7/17/2001

Item 12

Probe and noise considerations for Indian Point2

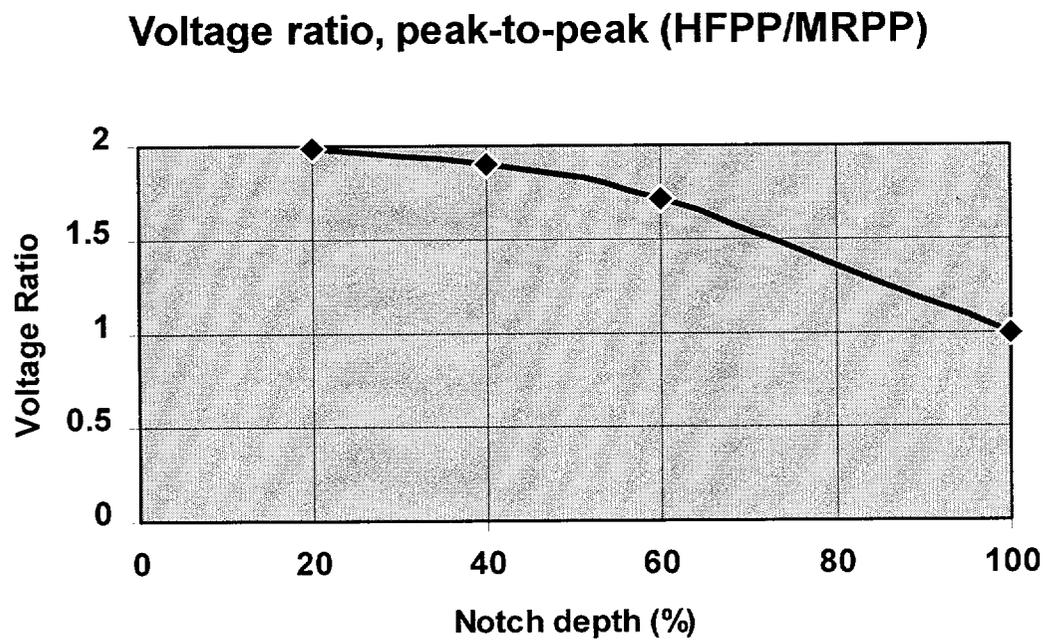
The growth studies should use the same type of probe, since the probe size has a significant effect on the measurements. Instead they used the smaller high frequency probe operated at 400 kHz. The growth studies that I did with the midrange probe showed a definite and considerable growth in voltage amplitude but little average growth in the defect depth. Part of the lack of depth growth could be due to poor signal-to-noise measurements. Both measurements on the standard and measurements on the actual defects show a marked increase in the voltage obtained for the defects. In Figure 1 we show the voltage ratio of the high-frequency, smaller probe to the midrange

probe. Since both probes are set at 20 volts on the 100% deep defect, the ratio is unity at this point. The average ratio of the three defects that had a good measurement of the maximum voltage was 1.42, which would

correspond to a defect about 70% deep. This curve is for the peak-to-peak voltage. The voltage measurement ratios for the vertical component of the high-frequency probe are slightly greater, since it has a larger phase angle.

Figure 1 Tube 2-71 of SG24 in 1997 at 400 kHz, with circular average filter applied.

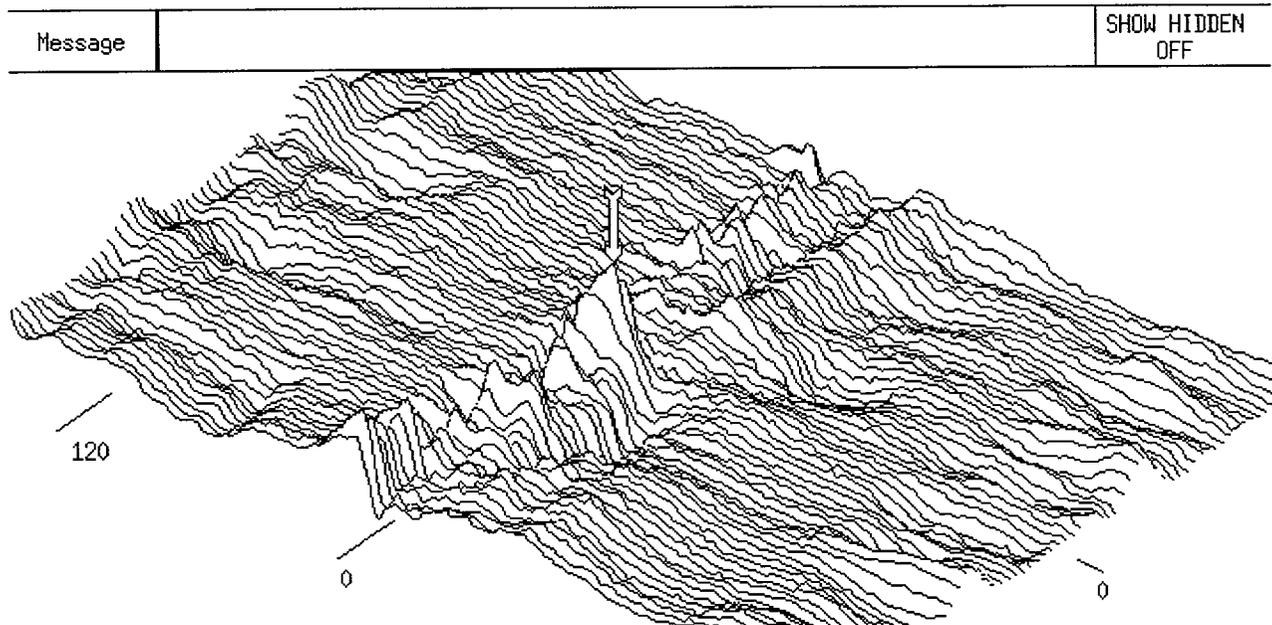
scan. Tube 2-71 and 2-85 need the circular average filter applied for detection.
